Access Compliance Report

Public Rights-of-Way

(Pedestrian Signals)

Intersection ID:	7452	Main Street:	N HOSKINS RD	Cross Street:	BEATTIES FORD RD	Location:	SE
ADA ID:	085524F5F68C	Signal Type:	One Push Button-APS	Overall Compliance:	No	Severity Score:	BTN 1: 45 BTN 2: N/A NO BTN: N/A
Codes/Mitigation Info/Possible Solution				Field Measurements/Component Compliance

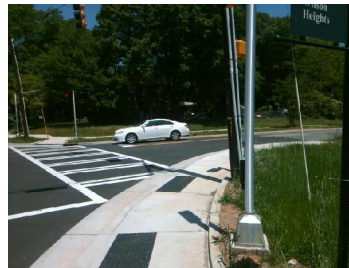
Possible Solutions: Remove & Replace
Replace APS Button With New APS Button.

PROW/ADA: R404.7.3, R209.1, MUTCD 4e.10
